# Independent Assessment of Basement Excavation Justification for Planning Application 2014/3668/P

| <b>Site:</b>    | 31 Briardale Gardens<br>London<br>NW3 7PN |
| <b>CCS Ref:</b> | BIA/4777 Revision 1                       |
| <b>Dated:</b>   | April 2015                                |

**Figure 1:** Extract from map of ‘Risk of Flooding from Surface Water’ on the Environment Agency’s website

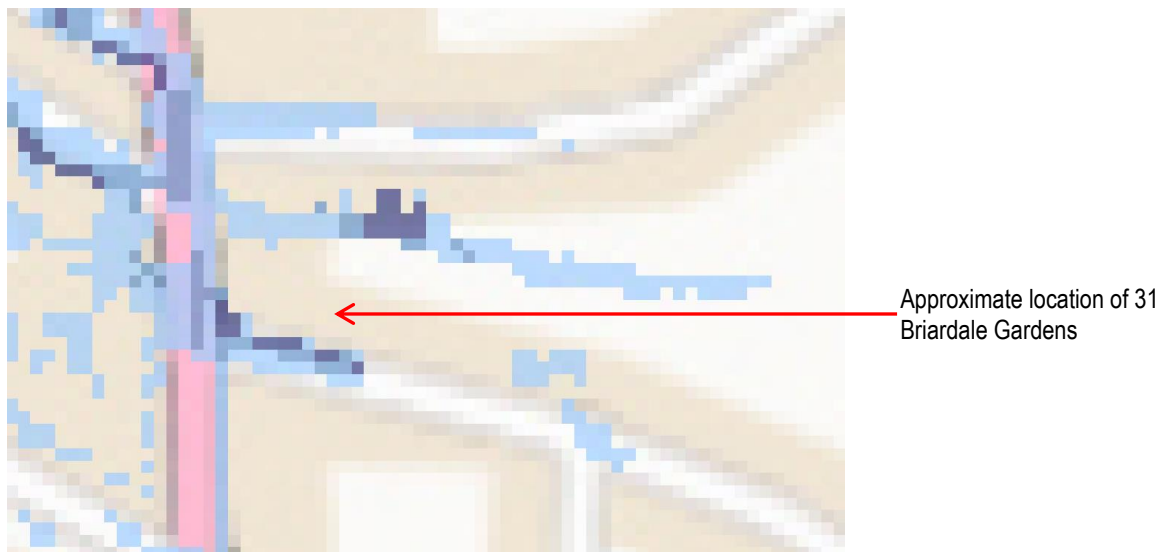
2.8.6 Issue 4(i): Dr de Freitas has suggested that construction of the proposed basement “within yards” of a “water channel” (now known to be a 9” diameter combined sewer, laid on the line of a former ditch) where there is a liability to surface water flooding along the line of the former ditch, would risk altering the relationship of the drain with the surrounding groundwater. He referred to the map of surface water runoff in Appendix D of LBC’s ‘Managing flood risk in Camden’ report; that map does show ponding in the area, but it is at a very low resolution so the extent is unclear. In contrast, the Environment Agency’s map of risk of flooding from surface water which we referred to previously is much more detailed (albeit pixellated); an extract is presented in Figure 1, which shows a ‘Low’ to ‘High’ risk of flooding in the rear gardens of the house on Pattison Road, but only the national background ‘Very Low’ level of risk in the rear gardens of the houses on Briardale Gardens.
